MEETING AGENDA
CITY PLAN COMMISSION
Wednesday, May 11, 2022
Work Session 9:00 a.m.
Public Hearing: 10:00 a.m.

D. *DEVELOPMENT REVIEW COMMITTEE (DRC) COMMENTS*

PRELIMINARY PLAT OF WEST SQUARE;

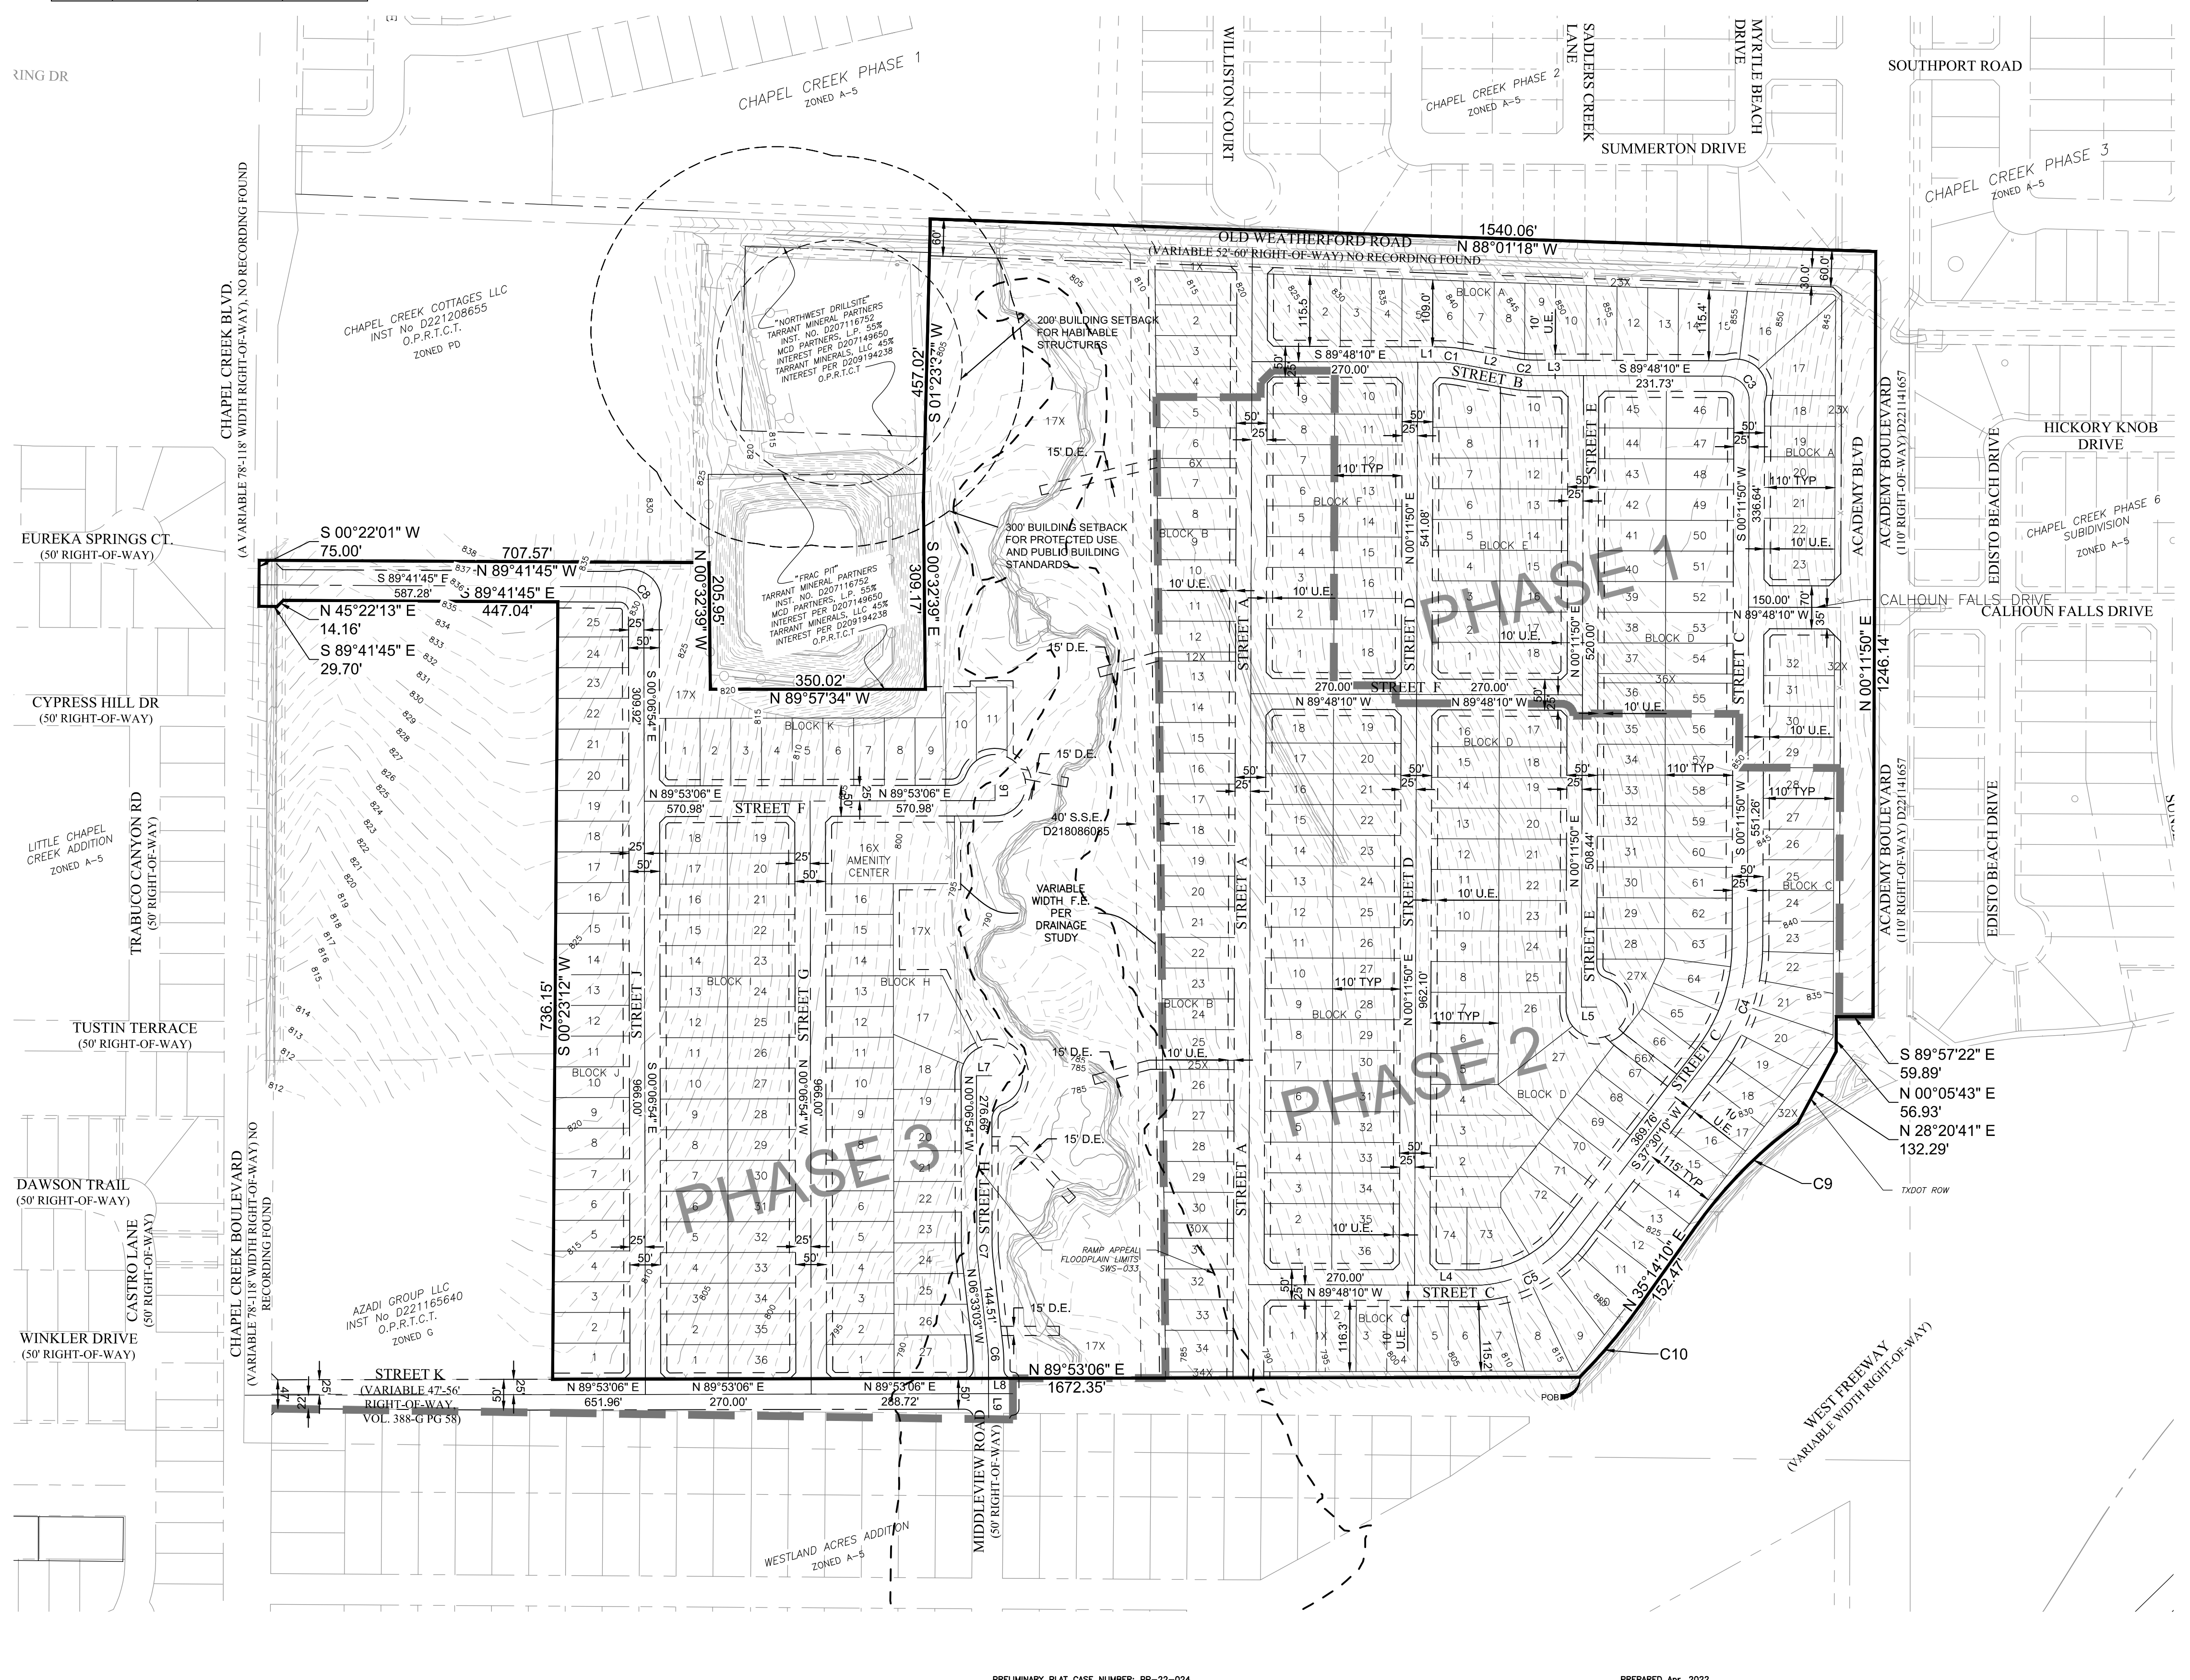
1. (Cleared 5-2-22)(FYI) Reference the case number on the plat PP-22-024.
2. Stubouts to adjoining un-platted tracts and street extension and continuation from adjoining developments. Urban local streets shall be extended to the subdivision boundary to connect with adjoining streets or where no adjacent streets are available for such connection with adjoining un-platted property [S.O. Sec. 31-106(c) A redesign or a waiver will be required from the City Plan Commission.

3. In Block B along streets A and C as it extends to the west and north exceeds the maximum block length allowed through the Subdivision Ordinance. Subdivision Ordinance in Section 31-106 (d) (2) states, "Standard public and private local streets that serve urban lots, less than 150 feet in width, shall have a maximum block face of 1,320 feet". The block faces for Lots 1-12, 17X, Block B and the extension of the roadway along Street D from Block B through Lots 6-10, Block I exceed the maximum distance of 1,320 feet. Redesign or a waiver from City Plan Commission would be required.

3. (Planning-MTP) Collector Streets ROW - Revise the 50' ROW to 60' on those residential streets that function as collector streets. Old Weatherford road is a collector. show 30' from the property line to the center line of the road. Improvements may be required subject to your rough proportionality.

4. (Records Management and Real Property) Variable ROW - Show the full ROW widths for all existing streets. For streets having variable ROW, call out the ROW as "Variable" and give "Range" of the ROW. Label the width for Old Weatherford Road.

- Show proposed Floodplain Boundary & Easement based on upcoming changes to FEMA Floodplain per SWS-033. Changes to FEMA Floodplain show the Floodplain boundary may encroach into the southern residential lots, so show the floodplain boundary based on SWS-033 & the proposed Floodplain easement based on the drainage study. Site will require FSR & LOMR to remove the lots from the Floodplain prior to PB issuance.

- Show proposed drainage easements for the 7 outfalls into the channel.

PRELIMINARY PLAT
WESTPOINT PARK
RE-PLAT OF NORMANDALE BAPTIST CHURCH OF BLOCK 1, BLOCK 1 TO
LOT 1-45, 1R, 45X, BLOCK 1; LOT 1-70, 1X, 2X, 70X, BLOCK 2;
LOT 1-32, BLOCK 3; LOT 1-33, BLOCK 4; LOT 1-39, 1X, BLOCK 5
EXISTING 'C', 'R2' AND 'CR' ZONING.

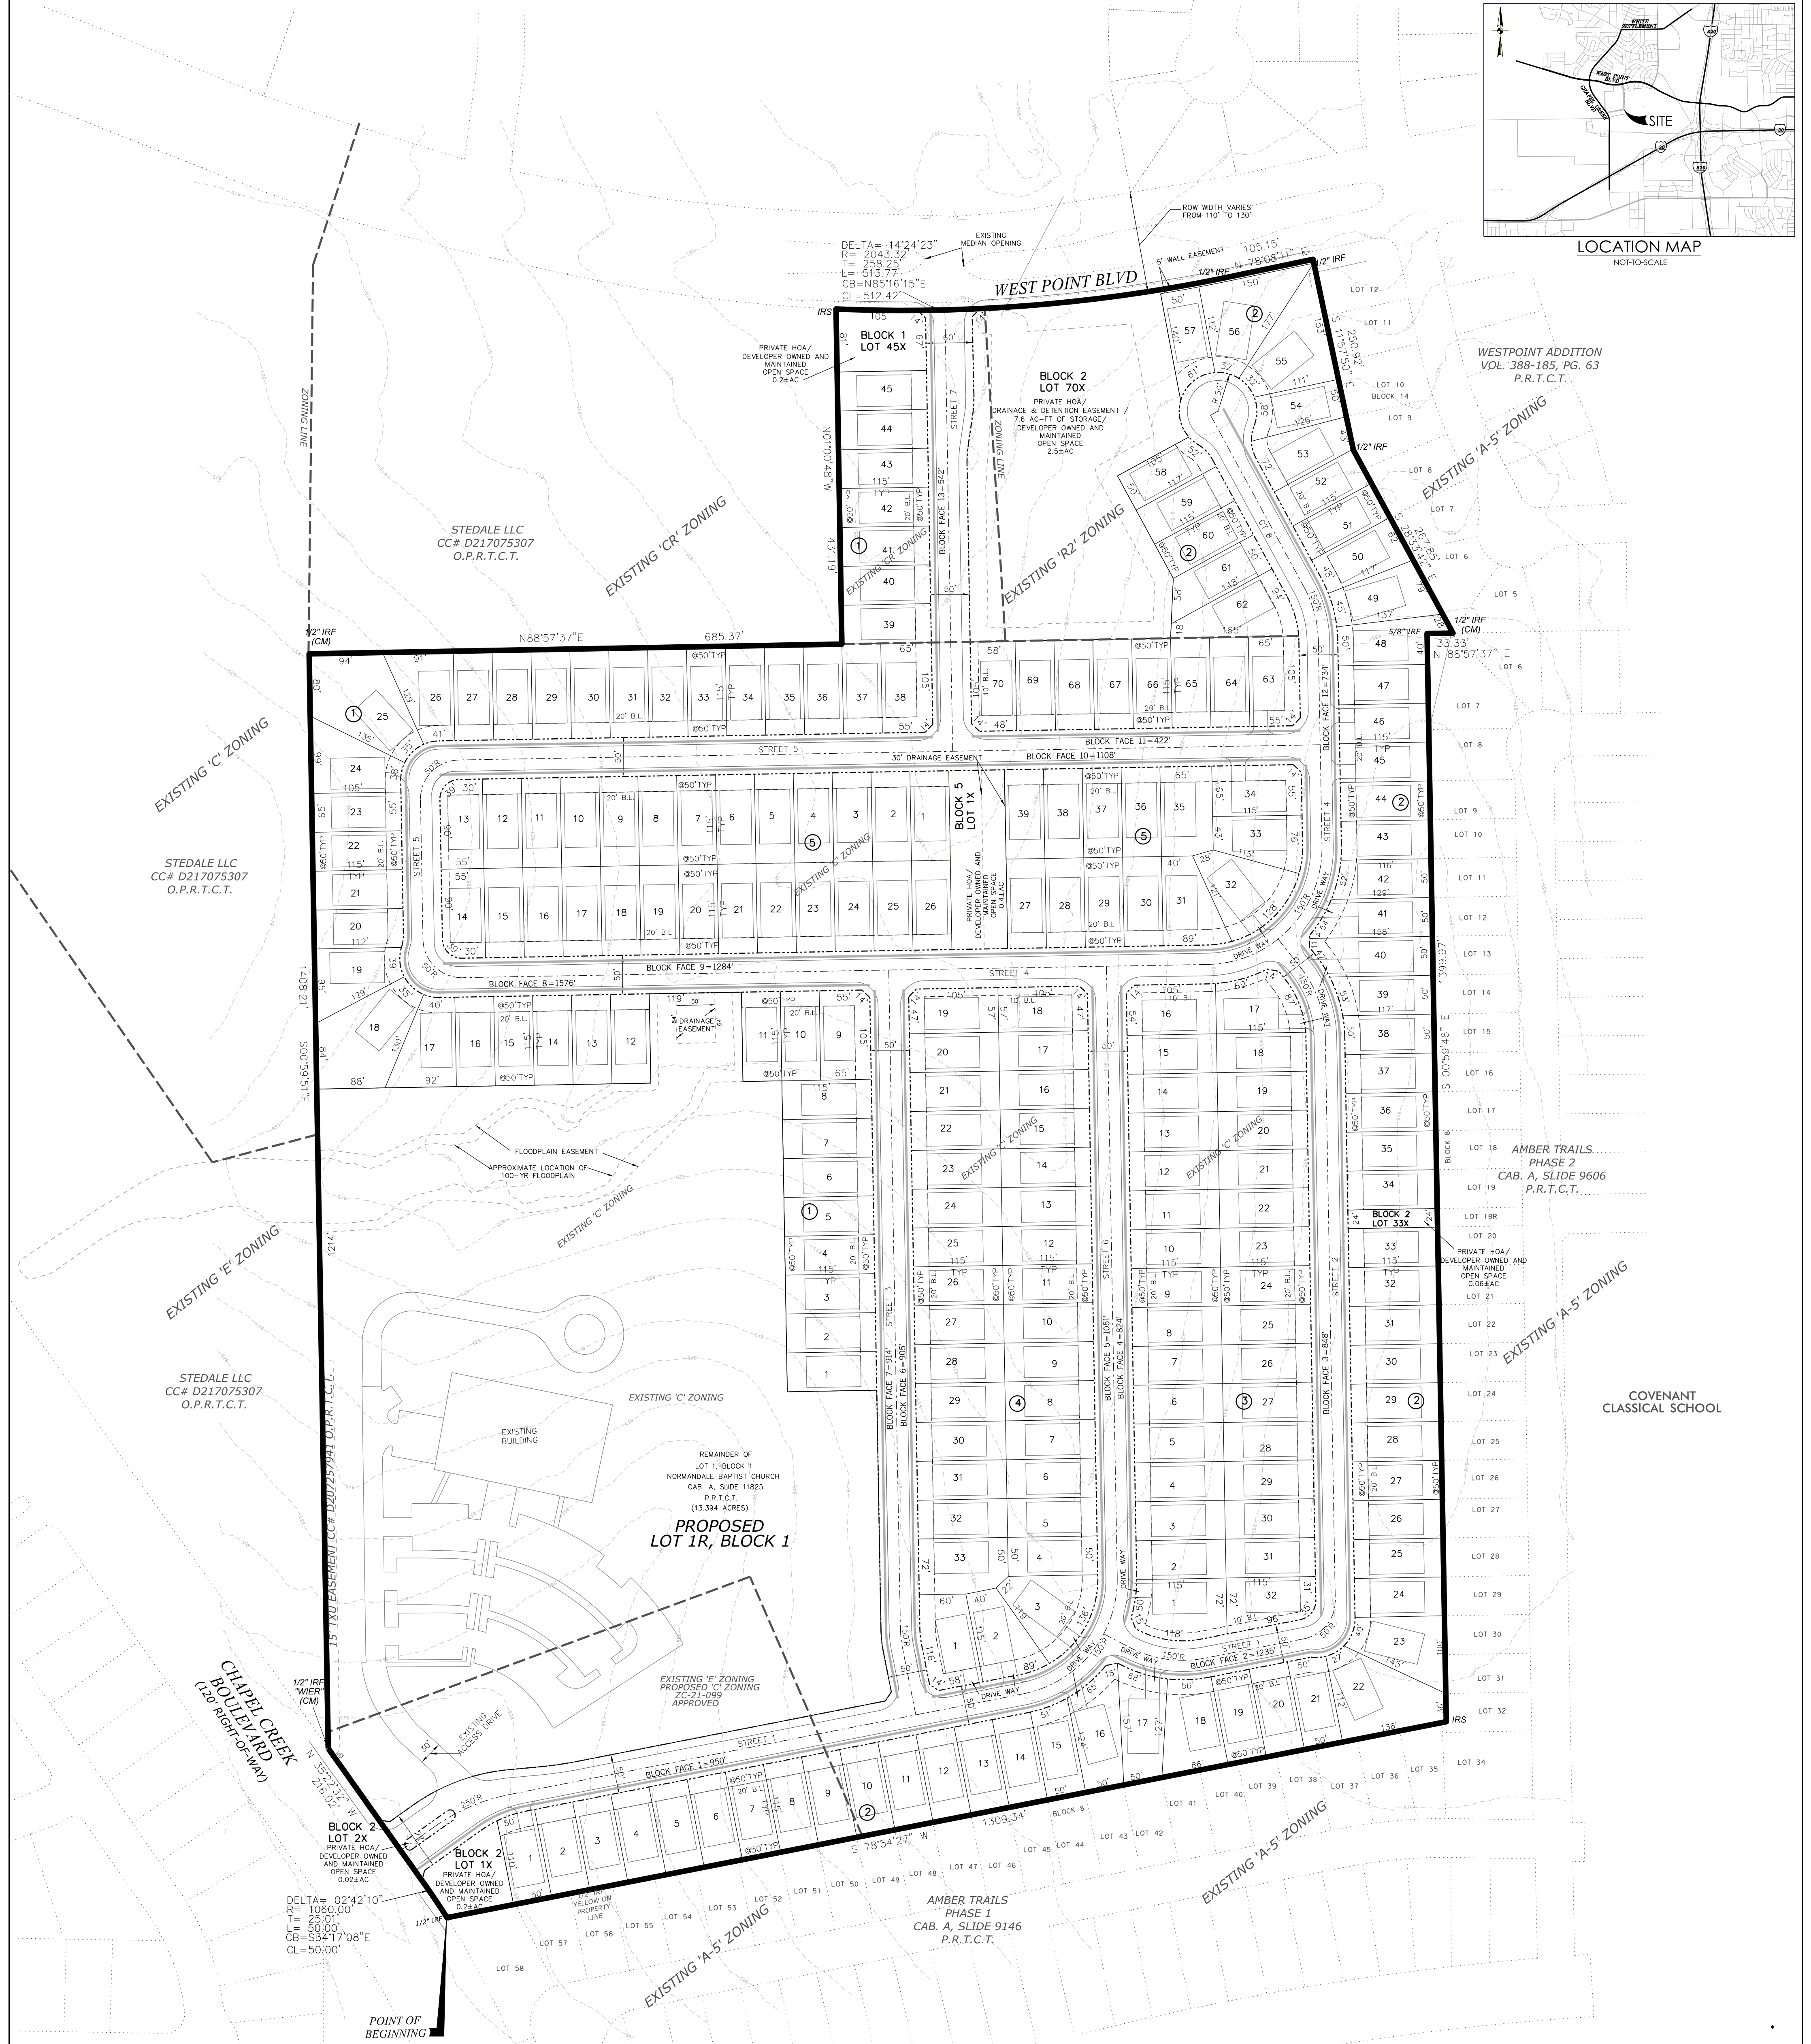
2. The Subdivision Ordinance in Section 31.-102 (b) (2) states, fragmented street systems impede emergency access and increase the number and length of individual trips. New residential subdivisions shall be designed to coordinate with existing, proposed and anticipated streets. Local and collector streets shall be extended to the tract boundary to provide future connection with adjoining un-platted lands. There are several un-platted tracts to the west that would require stubouts. Either a redesign or a waiver request will be required.

10 foot UE's will need to be added on property lines that meet road ways.

1. Chapel Creek Blvd and Westpoint Blvd are existing and correct.
2. Label Street 6 and Street 5 as the same street name.
3. Label the section of Street 4 with the cul-de-sac as a different street from Street 6 northward.
4. Label Street 1 and Street 2 the same street name from Chapel Creek Blvd to Lot 32 Block 3.
5. FYI: Show phasing if this is a phased development.
6. FYI: For the divided section of Street 1, 20' is required on either side of the median.

1. ROW Corner Clip (Subdivision Ordinance Ch.31-106.C.9)- A triangular right of way dedication measuring 10 feet by 10 feet, measured at the property line, is required on corner lots at the intersection of two streets in which there are no traffic signals or all-way stop signs; No dedication is required at all-way stops and signalized intersections.
2. (Records Management and Real Property) Variable ROW - Show the full ROW widths for all existing streets. For streets having variable ROW, call out the ROW as "Variable" and give "Range" of the Westpoint Blvd ROW.
